## **Eastowne SUP Medical Office Building (MOB) Comment Responses**

*September 19, 2018*

*The following information includes applicant and staff responses to a series of Council concerns that were originally published August 16, 2018. This document also contains additional Council questions (identified with an asterisk) that were received through September 12, 2018.*

## 2. Revised Elevations

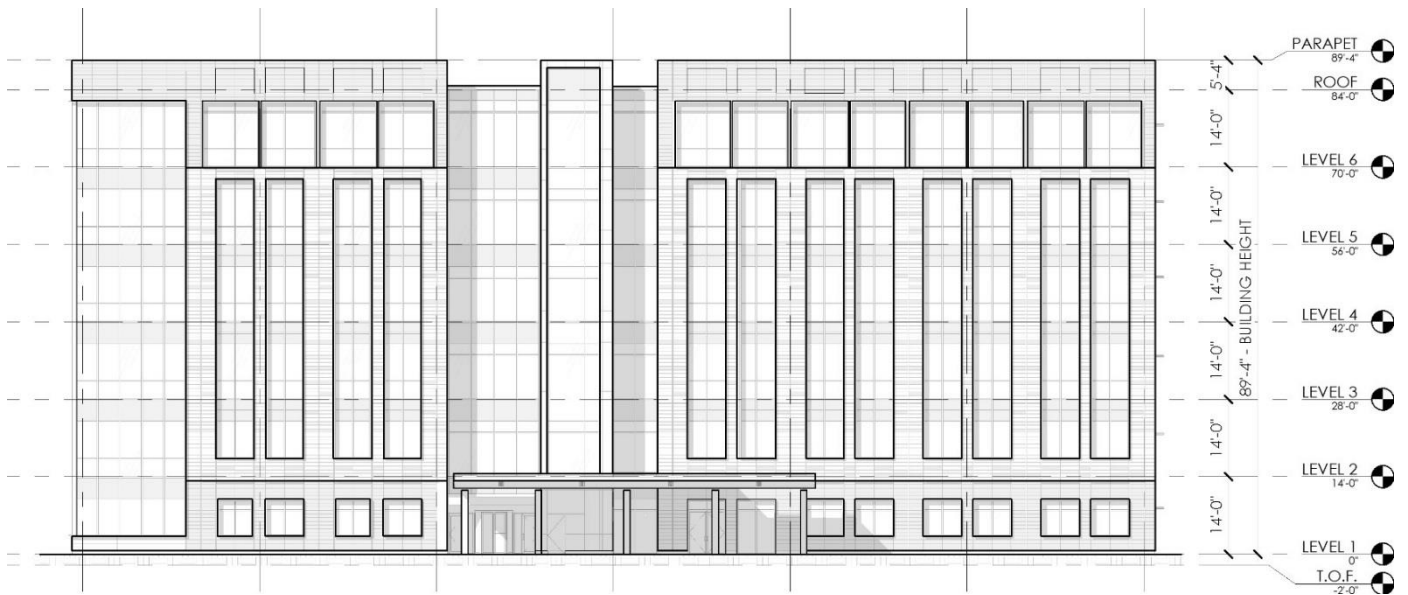
**2. It appears that the building will be 105 feet high, equivalent, perhaps, to a nine-story building. This building is too tall for the area and becomes the precedent for all future buildings in the area.**

Applicant Response: The proposed building is 6 stories (14' 0" typ x 6 + parapet) or 89'-4" with a ceiling height of 9 feet which provides additional clearance for specialty HVAC. Reducing floor to floor heights will lower the building height to under 90', which is modified from 5'. See following elevation and floor to floor section illustrating use of heights specified.

**3. cont'd.**

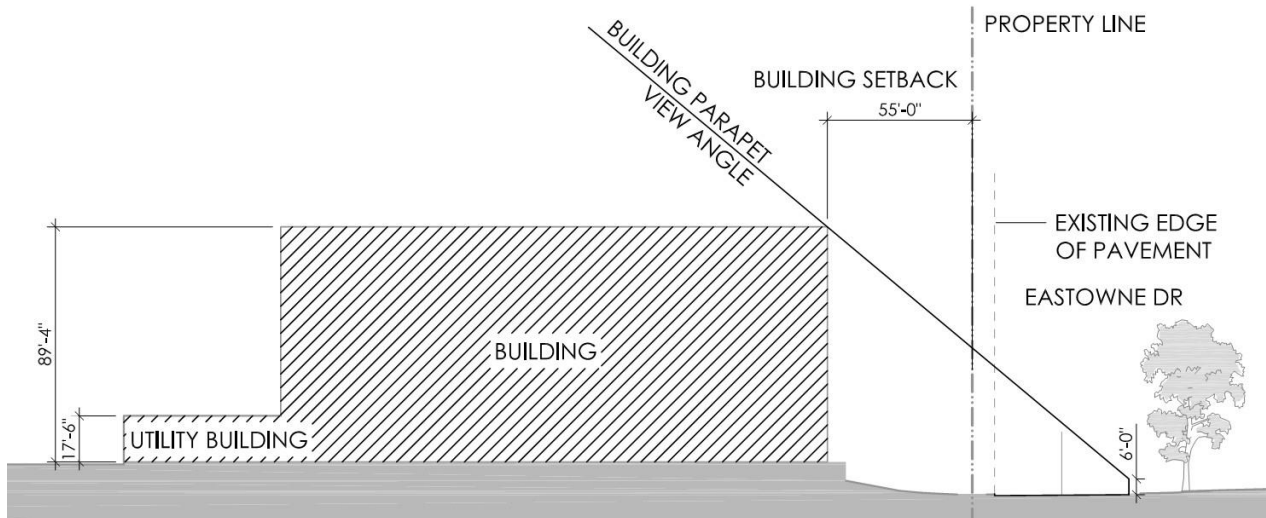
**3. This sets the tone for the whole 15-501 corridor. Will there be requests for even higher buildings in this section of town? With Gateway & SECU Developments, the feel of coming into such tall buildings at this main entrance to Chapel Hill is important. / Being so large so close to the road, makes the building feel even bigger. Our interest is urban design but not at the expense of feeling like a canyon down 15-501**

Applicant Response: Building is set back from 15-501 a distance of 112'. We are

proposing to preserve a considerable amount of the buffer vegetation and even with future road widening along 15-501, there will still be 100' of separation. The required on-site 30' buffer is being maintained. Also, please note that the building height is less than the set back from the edge of pavement. This creates a commonly accepted 1 to 1 ratio.

Applicant Response: Building is set back from Eastowne by 55' and parking deck by 52'. Below is a site section showing position of Eastowne relative to building and parking structure.

**5. Illustrations cont'd. Below is a comparison between BCBS height relative to 15-501 as well as the proposed Eastowne MOB.**

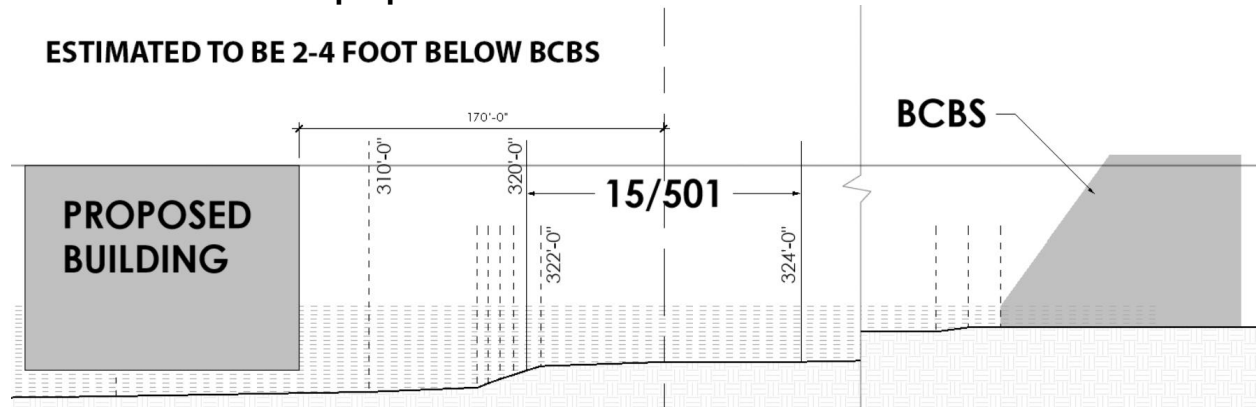
**5. Where is the best place for the mechanicals of the building?**

Applicant Response: There are small fans and mechanical equipment located on the roof within the 90' limit on height. Air cooled chillers are located and screened behind the small, single story utility building which is located approximately 10' below 15-501 elevations and any exterior mechanical units will also be shielded from view by an evergreen landscape. See following line of sight drawing for further clarification.

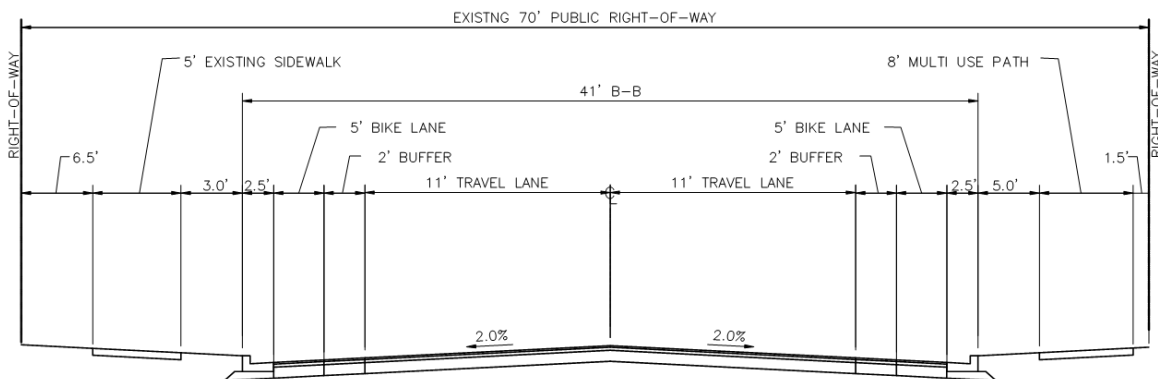
**11. Need to make sure there is no traffic stacking onto 15-501 from this entrance or even between the two lights at Eastowne Rd and Lakeview Rd intersection.**

Applicant Response: Improvements will be made as recommended in the TIA.

Staff Response: The TIA addresses this concern and improvements are addressed in the report.

### 13. Cont'd

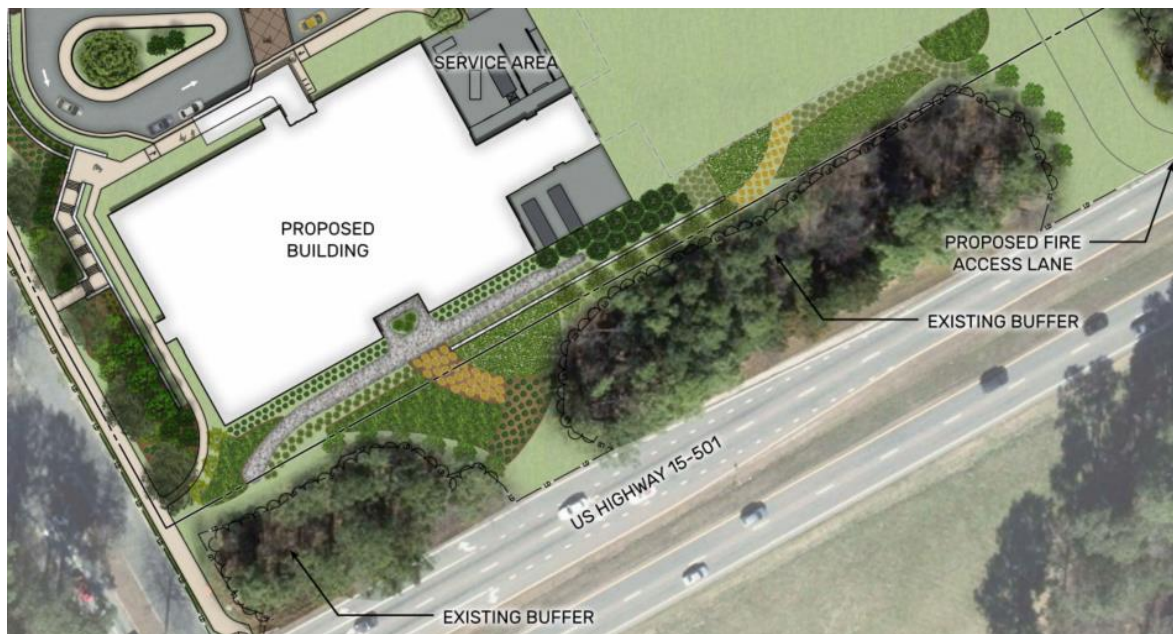
**13. Consider traffic circle in front of parking deck – there is already a great number of cars coming down Eastowne Rd from other medical & apartment complex such that making a left turn out of the parking deck onto Eastowne Rd is complicated – maybe not for first building but for full build out – at least plan for this to help with traffic flow. Adding this number of cars into one entrance is huge for this section of road – traffic circle or something to keep movement and prevent stacking in either direction**

Applicant Response: We considered a traffic circle at this location and determined it created several impacts to the project and adjacent landowners, including the loss of full access movement for Pinegate Apartments, and impact on existing environmental features. A traffic circle may be viable with the future Pinegate redevelopment but should be evaluated with overall Master Plan.

Staff Response: We believe placement of a traffic circle at the parking deck entrance may cause conflict with the Pinegate Apartments driveway. It is recommended as part of the Master Plan traffic impact scope of work that a traffic circle be considered at the intersection of Eastowne Drive and Old Sterling Drive.

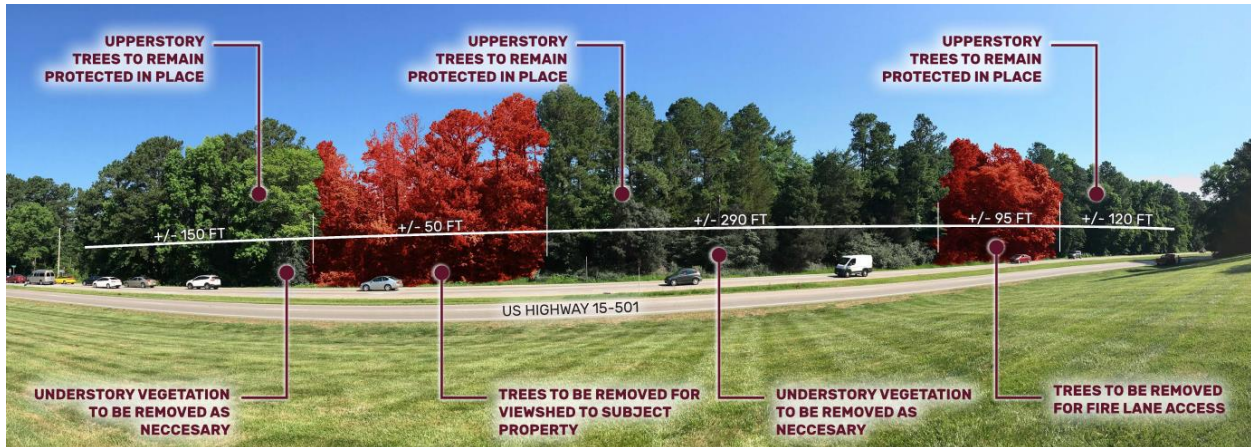
**16.** This is a tall building and will be visible above tree level, want to maximize tree feel along 15-501 corridor. Leaving existing mature trees in buffer areas

Applicant Response: We propose the following changes to the buffer in lieu of clearing, grading and installation of greenway along 15-501.

- Poor quality understory vegetation to be removed to clean up buffer.
- Trees in viewshed are poor quality.

Applicant Response: For further clarification, here is a panorama of the proposed buffer and proposed project.

Staff Response: The applicant has revised the plans, and additional trees along the US 15-501 frontage are being preserved.
